PLANNING CLEARANCE

GRAND JUNCTION COMMUNITY DEVELOPMENT DEPARTMENT

DESCRIPTION OF WORK AND INTENDED USE: Beaches along 3rd Base line @ Saplizio Field

CITY OF GRAND JUNCTION SQUIPHERD FIELD			WO BASEBALL STANDS ADDITION	
SCALE 1"=20'			SITE PLAN	
DATE	BY	670 - 23 ROAD - GRAND JUNCTION, COLORADO 81505 9303-243-9170		
INCHES	DATE	BY	DATE	DRAWN BY
		LOPE		RON

SITE PLAN
1"=20'

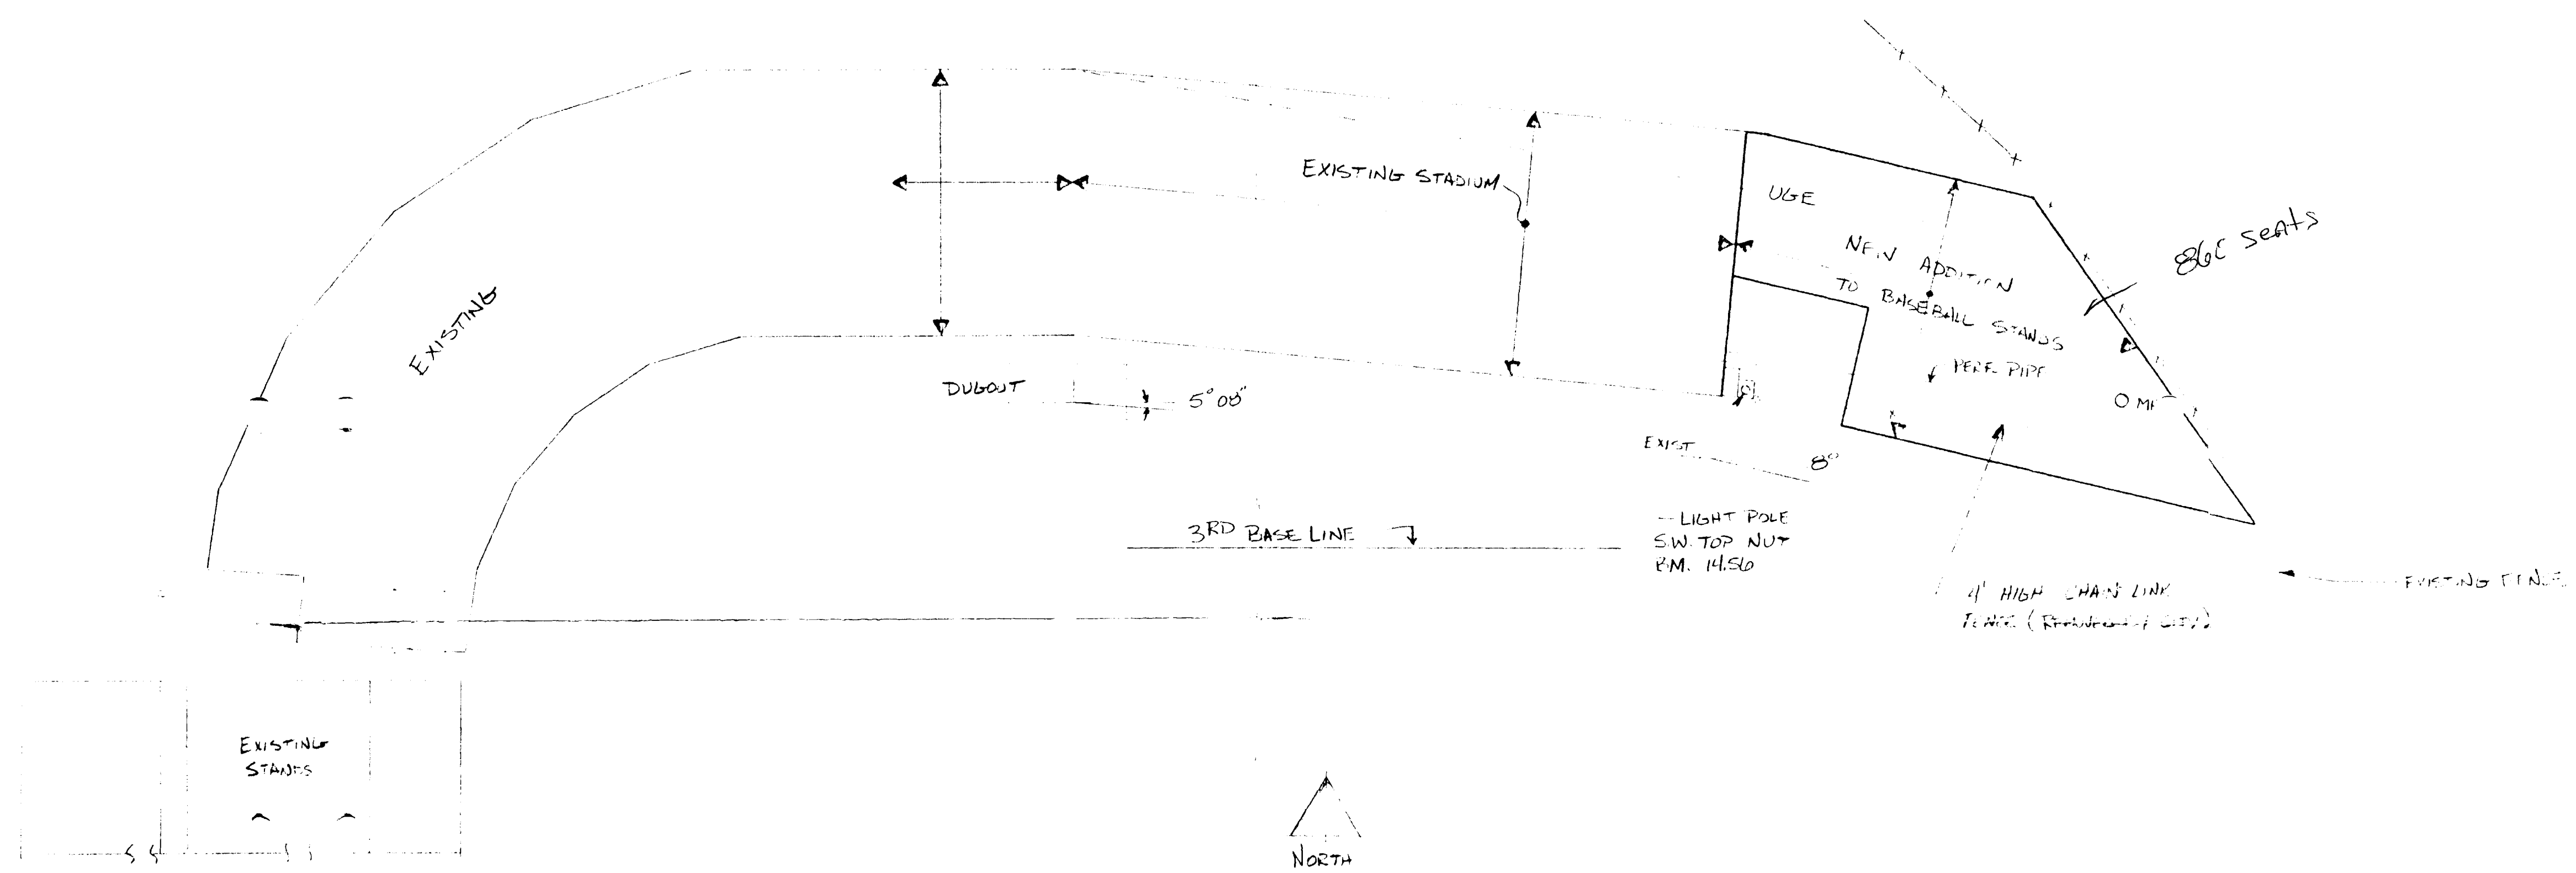
SPECIAL CONDITIONS:
PARKING REQUIREMENT
OF THE CODE - WE UNDERSTAND
THAT AN AGREEMENT WILL BE

MADE WITH MESA STATE COLLEGE
FETC. WITH ADDITIONAL PARKING
WITH POSSIBLE SHUTTLE BASES

The addition of 700 seats at Suplizio Field would require, if treated as a "theater," under section 5-5 I. 3 of the Grand Junction Zoning and Development Code, 175 additional off-street parking spaces. Section 5-5 J. allows for a "reasonable reduction" based on factors including situations where employees do not own or drive cars. You have stated that Juco actively encourages people to park in the Mesa State College parking lots at Saunders Field House and that there are approximately 590 parking spaces at this location. This lot is more than 200 feet from the stadium, and so does not comply with section 5-5-1 E or F.

The use of shuttle buses together with signs and advertisements of the alternate parking at the Mesa State lots would provide a suitable alternative under section 5-5 J for Juco and other peak events at the stadiums. The longer range solutions will emerge from the master planning process.
